PROJECT LAYOUT SHEET #12	PROJECT NAME: MIDDLEBURY	PLOT DATE: 18-SEP-2013 17:09
	PROJECT NUMBER: STP 2627(1)	DRAWN BY: C.A.K.
	FILE NAME: p06c222.dgn	CHECKED BY: D.W.E.
	PROJECT LEADER: D.E.G.	SHEET 31 OF 114
	DESIGNED BY: M.J.L.	
	IPARM FILE: p06c222112.i

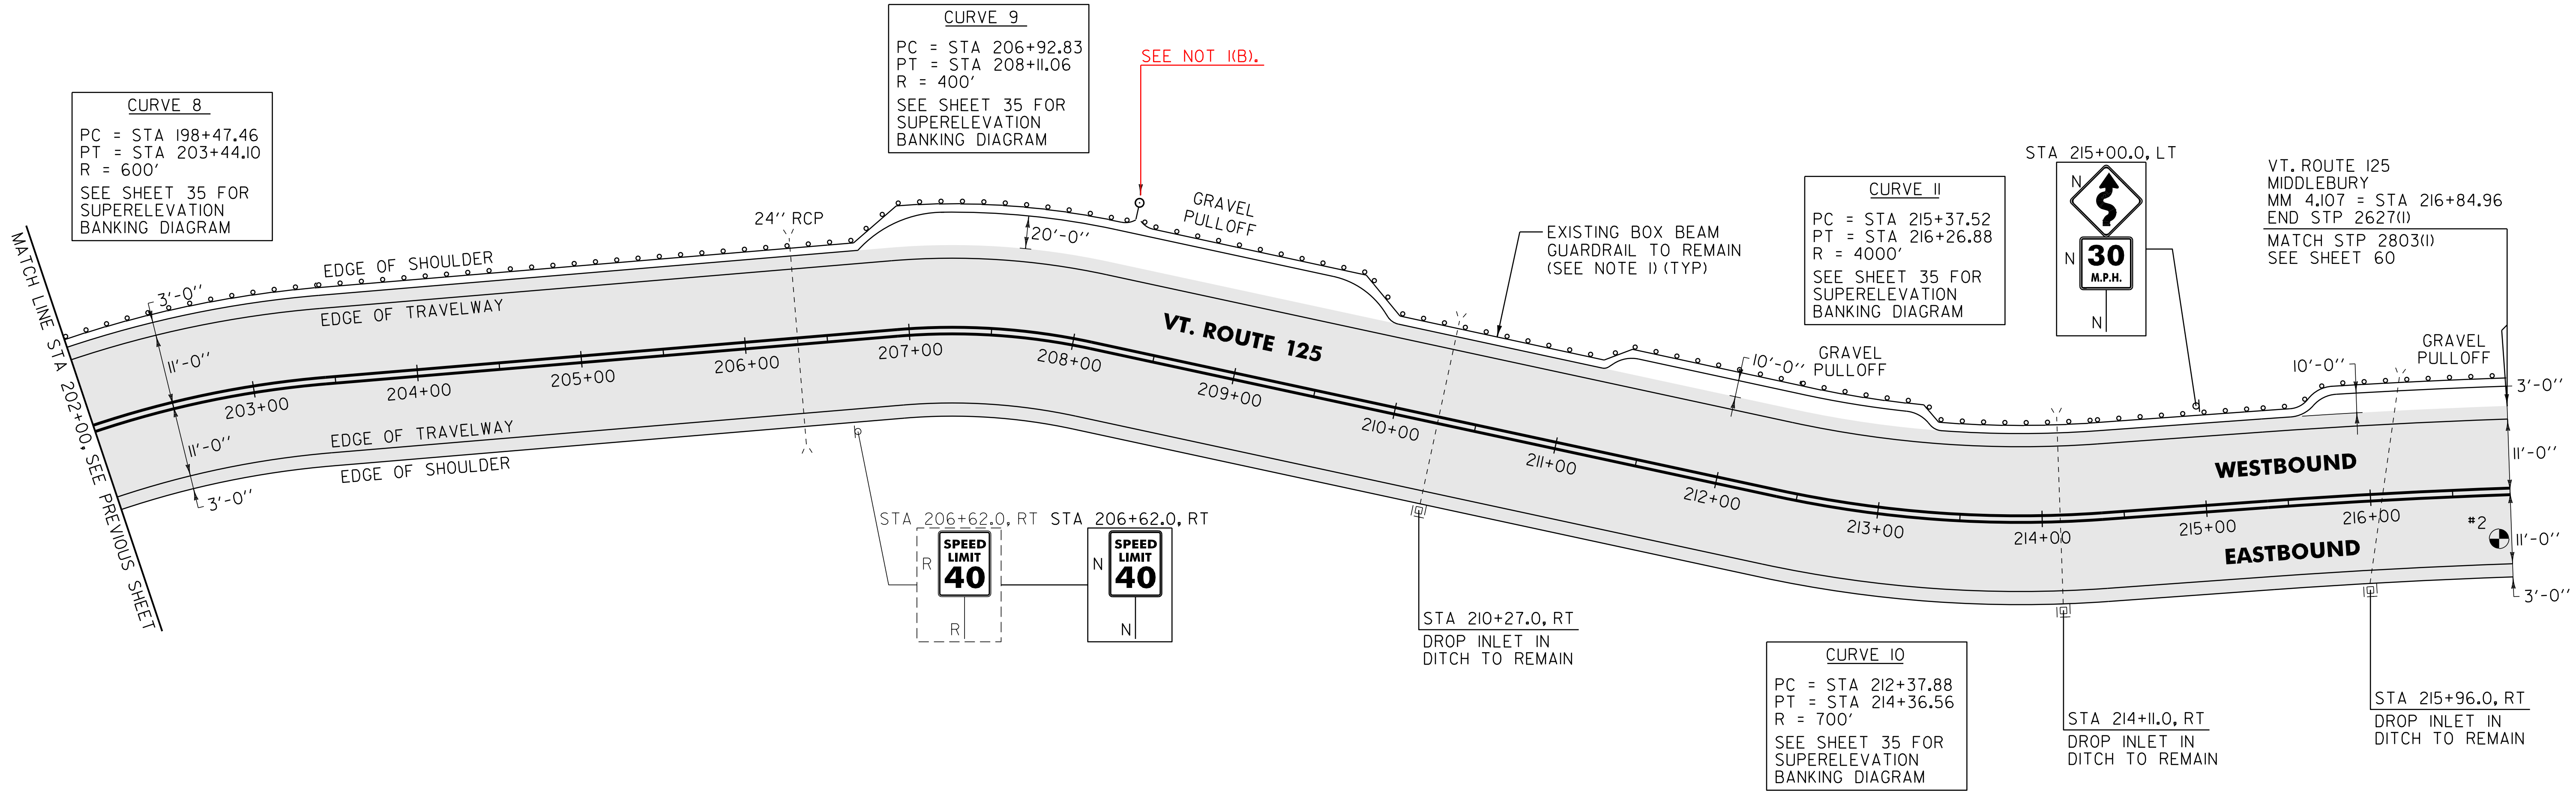
STA 208+30 LT TO STA 216+84.96 LT
 WILL BE PAID UNDER ITEM 900.640
 SPECIAL PROVISION (STEEL BEAM GUARDRAIL, WEATHERING)

~~621.80 REMOVAL AND DISPOSAL OF GUARDRAIL
 MIDDLEBURY:
 STA 202+00.0 - STA 208+26.0 LT (626.0 LF) - STA 216+84.96 LT~~

~~676.10 DELINEATOR WITH STEEL POST
 MIDDLEBURY:
 STA 208+26.0 LT~~

~~900.620 SPECIAL PROVISION (MANUFACTURED TERMINAL SECTION, FLARED/WEATHERING)
 MIDDLEBURY:
 STA 207+88.5 - STA 208+26.0 LT~~

900.640 SPECIAL PROVISION (STEEL BEAM GUARDRAIL, WEATHERING)
 MIDDLEBURY:
 STA 202+00.0 - STA 207+88.5 LT (588.5 LF) - STA 216+84.96 LT
